# City of Lee's Summit

TO: Board of Zoning Adjustments  
FROM: Hector Soto, Jr., AICP, Senior Planner  
RE: **PUBLIC HEARING – Application #PL2024-159 – Variance to Unified Development Ordinance (UDO) Article 6, Section 6.040, Table 6-3, Rear Yard Setback – 5286 NE Ash Grove Ct; Graber Outdoors, applicant**

Application #PL2024-159 – Rear Yard Setback – 5286 NE Ash Grove Ct

Figure 4 - Plot plan showing proposed replacement deck and catwalk shaded in red. Stairs shown with hatching.

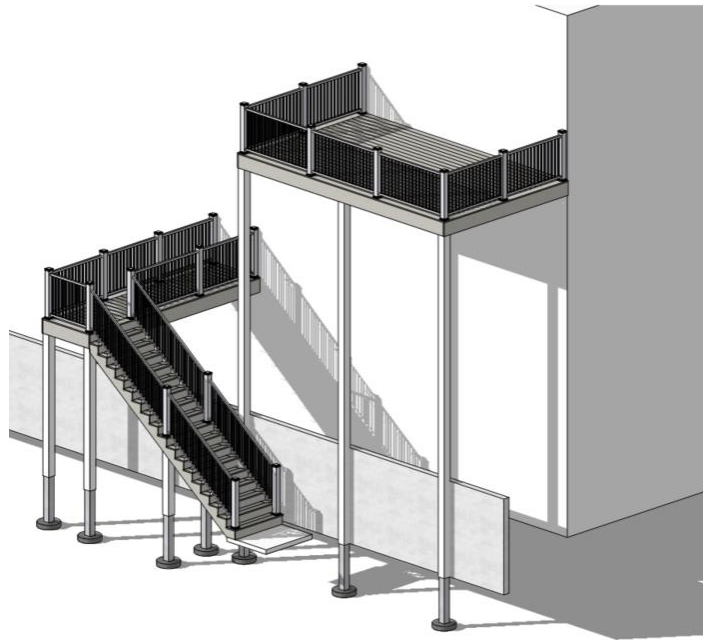
**Request.** The applicant proposes to replace the two (2) existing decks with one (1) upper level deck of the same dimensions as the existing upper level deck and one (1) lower level catwalk with stairs down to the back yard. The upper level deck will be 12' deep x 20' wide and maintain the existing 23'-5" rear yard setback. The lower level catwalk will be 4'-6" wide and come out 16'-6" from the house, to allow access from a back door to the back yard. The catwalk will be set back 28'-8" from the rear property line, which complies with the minimum 25' rear yard setback.

It is not impossible for the replacement structures to comply with the 25' rear yard setback. This will require reducing the depth of the upper level deck by 1'-7", yielding a deck with a reasonable depth of 10'-5". The catwalk meets the rear yard setback requirements under its proposed configuration.

The need for a variance can feasibly be obviated by reducing the depth of the proposed replacement upper deck by 1'-7" from 12' to 10'-5". However, the applicant seeks a replacement deck with the same 12' x 20' dimensions that have existed on the property since 1994.

The Development Services Department recommends **APPROVAL** of a 1'-7" variance to the minimum 25' rear setback requirement for an uncovered deck in the R-1 zoning district, to allow an uncovered deck to maintain a 23'-5" setback from the rear property line.
